MISSISSIPPI POWER & LIGHT COMPANY

SUBJECT: Grand Gulf Nuclear Station
Units 1 and 2
Docket Nos. 50-416 and 50-417
License No. NPF-13
File 0260/0272/L-860.0
Final Information to Close
Humphrey Concerns
AECM-82/574

Attachment 1 to this letter contains the balance of the information which Mississippi Power & Light Company (MP&L) committed in reference 1 to submit to your staff. This information completes the program which MP&L undertook to respond to the design questions raised by Mr. John Humphrey.

## ATTACHMENT 1

FIGURE 5-2

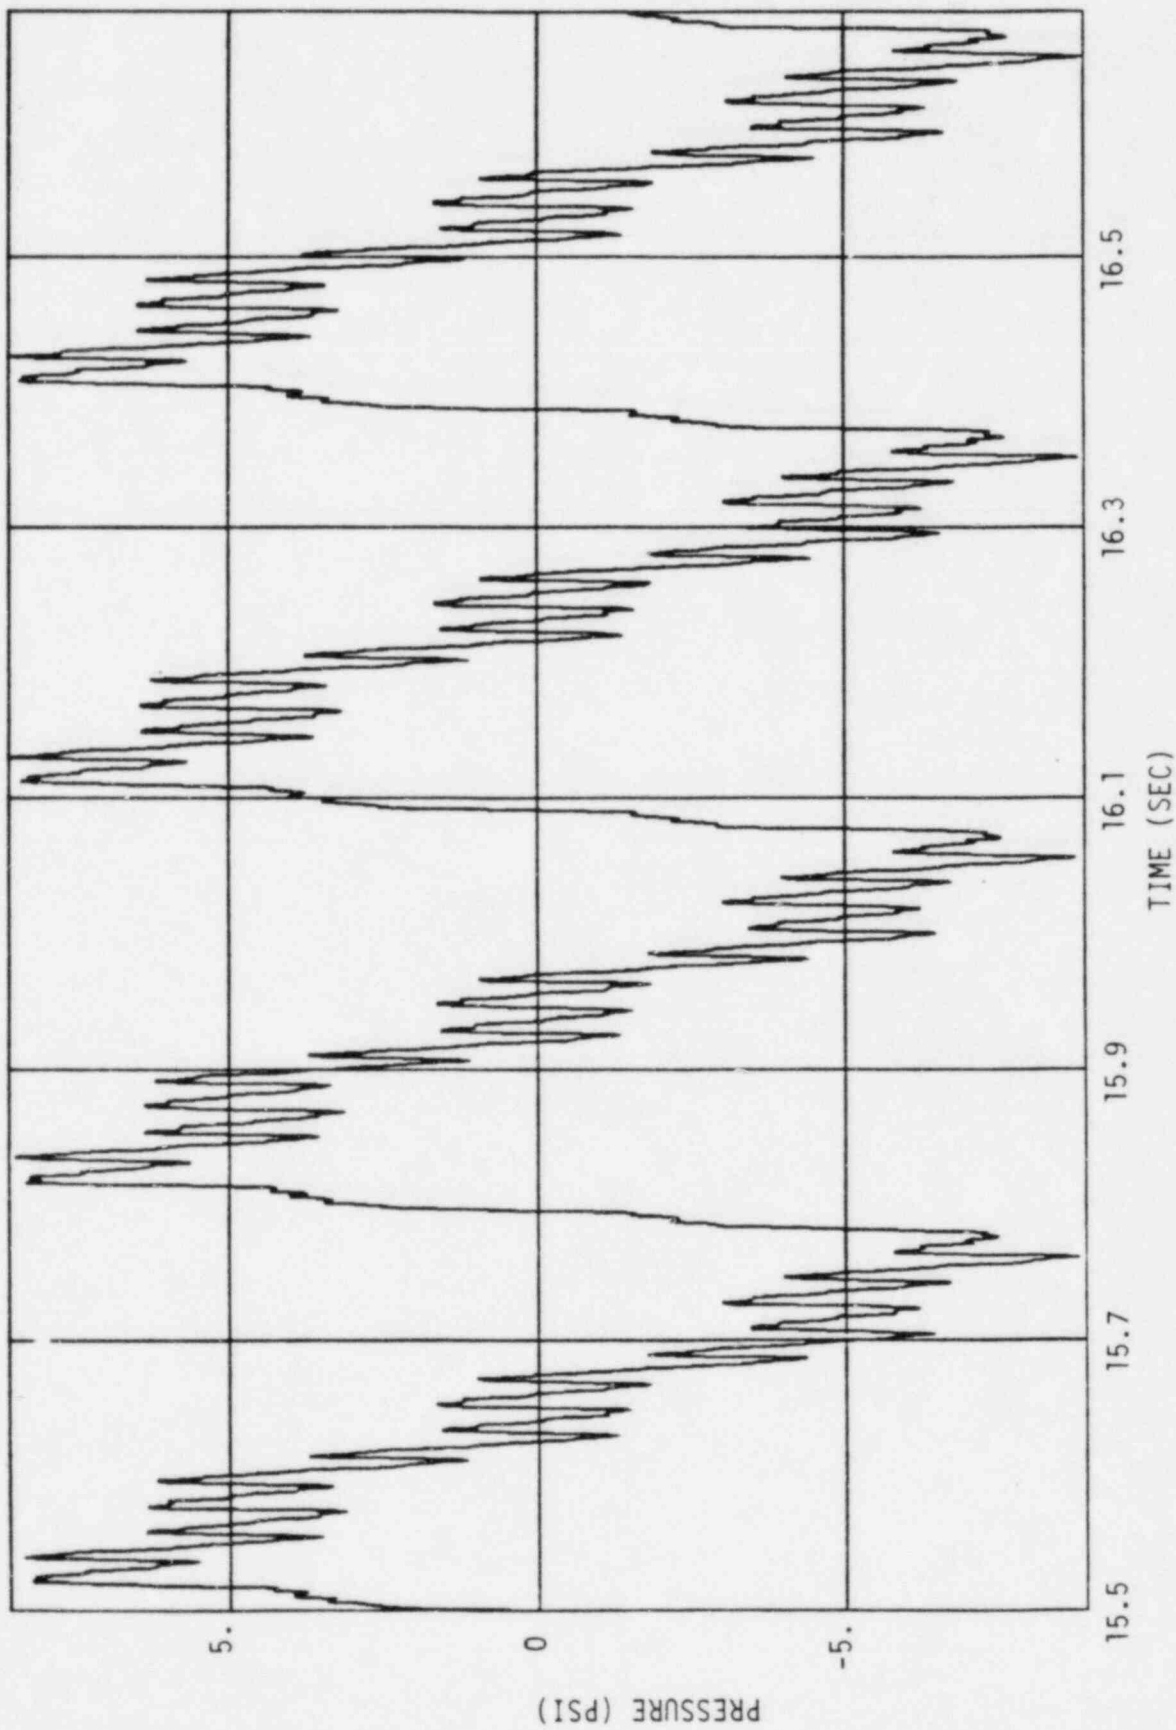
A portion of the resulting pressure time-history on the drywell wall for Grand Gulf is shown in Figure 5-2 (vent C.O. only) and Figure 5-3 (simultaneous vent and sleeve C.O.).

The pressure time-histories of Figures 5-2 and 5-3 were digitized and Amplified Response Spectra (ARS) plots were prepared. Peak broadening of 15 percent was used, as in the GESSAR II C.O. load, to account for uncertainty in the predicted frequencies. The ARS resulting from the time histories given in Figures 5-2 and 5-3 are shown in Figures 5-4 and 5-5. As is evident from these plots, the SRVDL sleeve C.O. has no impact below 30 Hz. Superimposed on Figure 5-5 is the ARS of the chugging load on the drywell wall (Reference 6). In the frequency range of the sleeve C.O. pressure, signal, the chugging load is bounding by a substantial margin, even though an unrealistically large pressure due to the sleeve was utilized and credit was not taken for attenuation of the SRVDL sleeve C.O. as distance away from the sleeve increases.

FIGURE 5-4

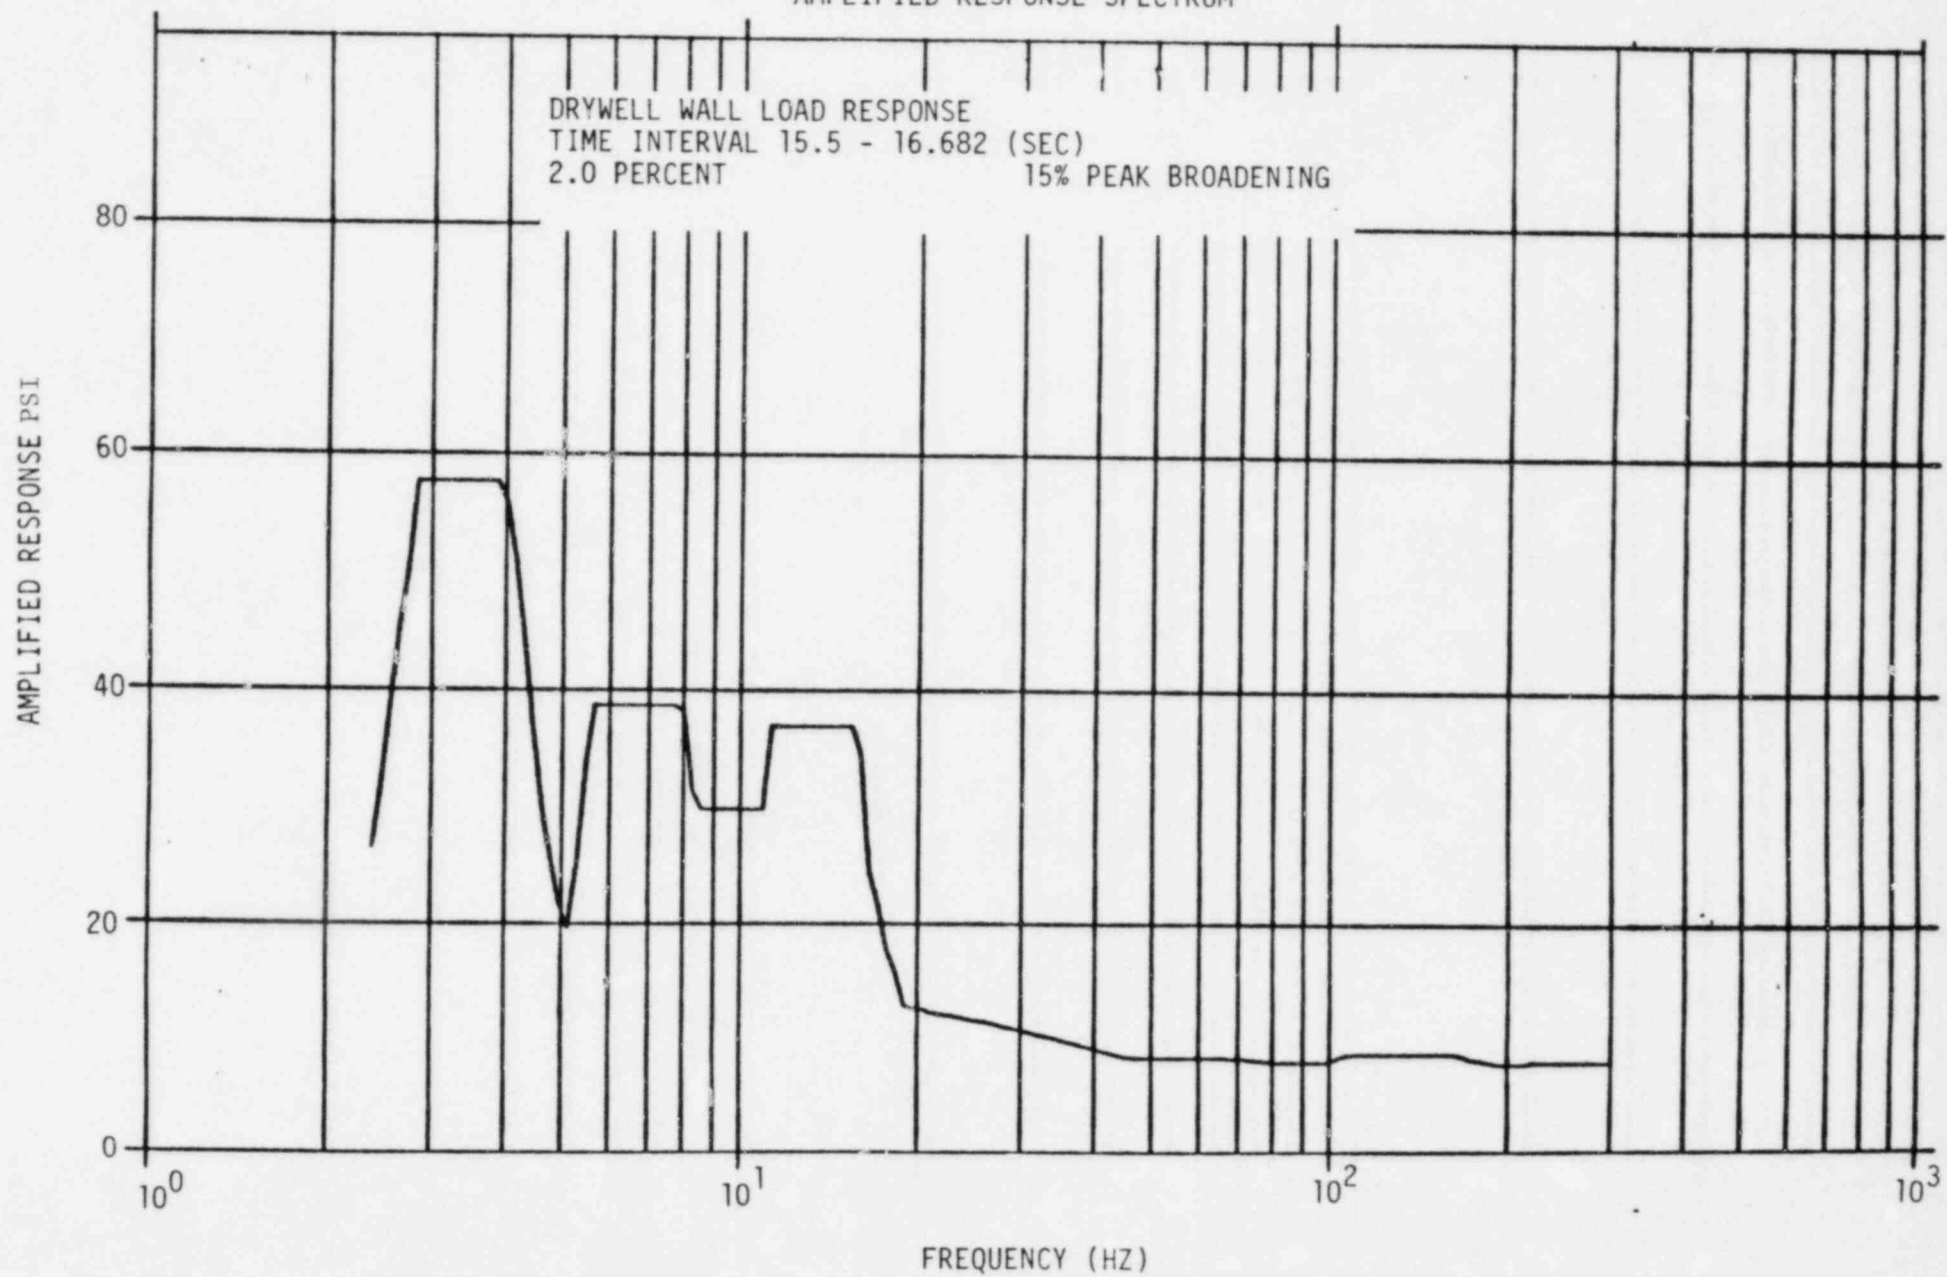
Figure 5-4 does not correspond directly to the design basis accident ARS presented by Grand Gulf in support of the LOCA Licensing defense. Due to limitations in the existing code, a smaller number of cycles was used in Figure 5-4 to obtain the (DBA) C.O. peak response at the low frequency range than were used in developing the DBA C.O. ARS. At the high frequency range, however, the number of cycles used is adequate to reach the peak response and Figures 5-5 and 5-6 adequately represent the maximum amplitudes produced by the high frequency components of the CO. load.

FIGURE 5-5

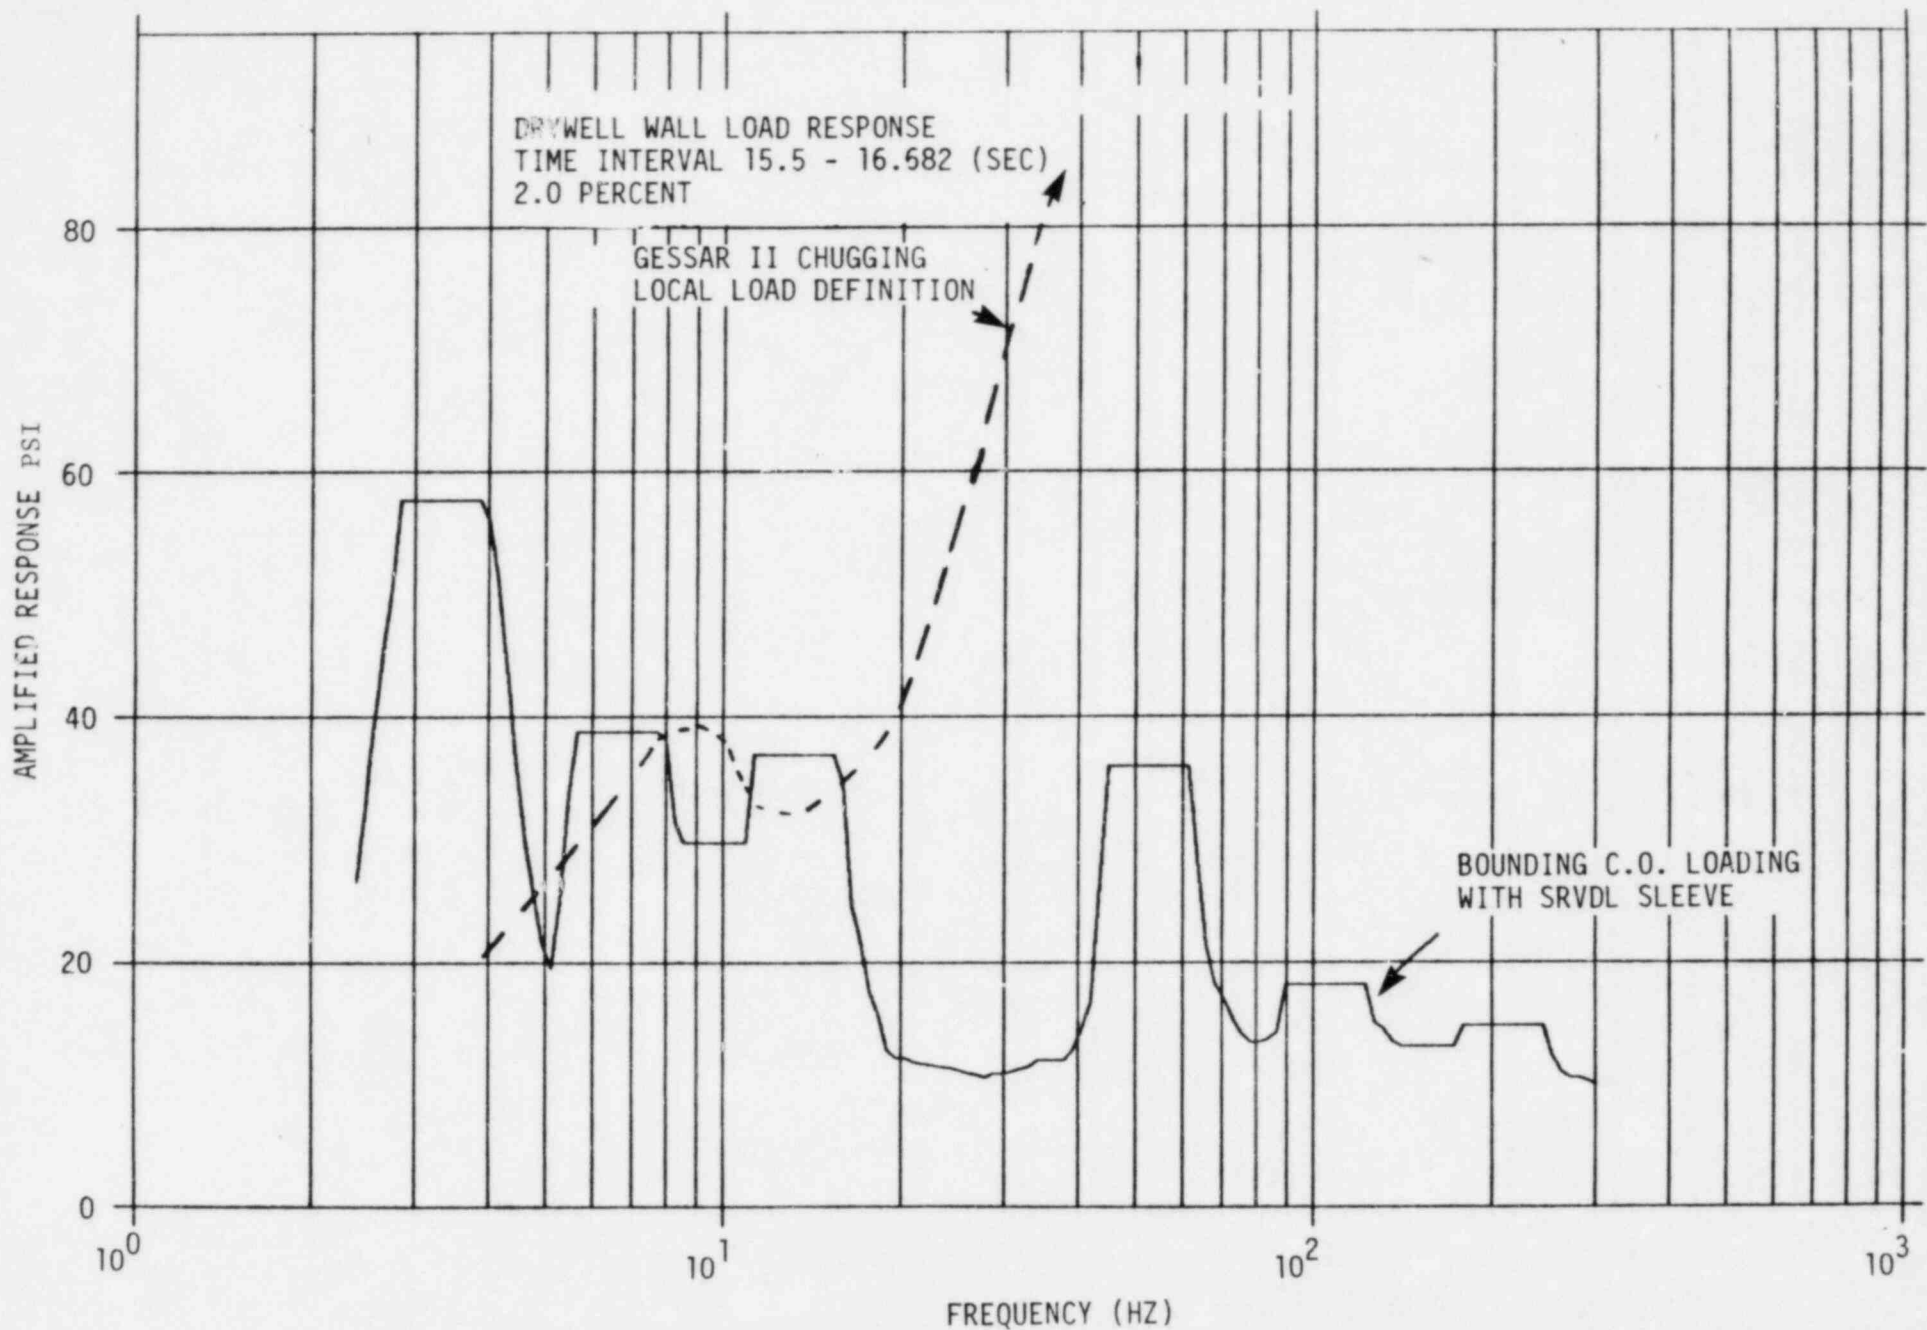
As shown in Figures 5-5 and 5-6, the presence of C.O. in the SRVDL sleeve vent creates new pressure peaks at frequencies of approximately 50 hz and 100 hz. These frequencies are considerably above the structural resonance frequency of the drywell and containment walls which is 13.55 Hz.
